SERVICE BULLETIN

M1678: NEW MAXI FUSE LOCATION FOR REVOLUTION MAX VEHICLES AT PDI

M1678

Figure 1. Pan America Maxi Fuse Location

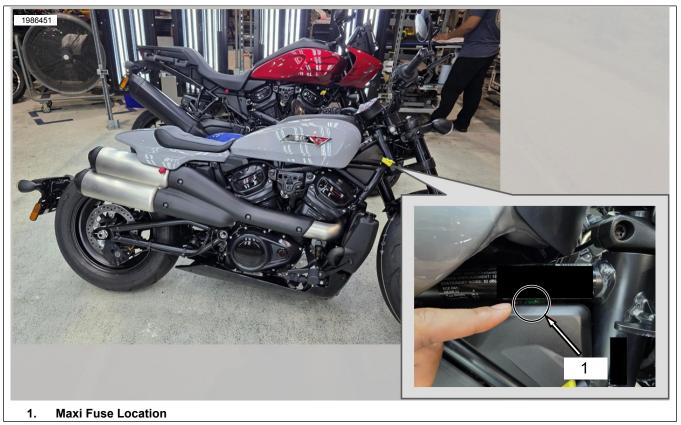
This bulletin informs dealers that on all 2025 Revolution® Max vehicles shipped from the Thailand factory, the location of the 40 A Maxi Fuse (main) has changed.

Production of **all** Revolution® Max vehicles has been moved to the Thailand plant for model year 2025. Some of their delivery processes will differ from prior production. On all Revolution Max vehicles, the Maxi Fuse will be shipped **under the front side cover instead of being in a plastic bag** attached to the connector.

1. Before notating a missing maxi fuse on the BOL, verify that it is not under or near the front side cover.
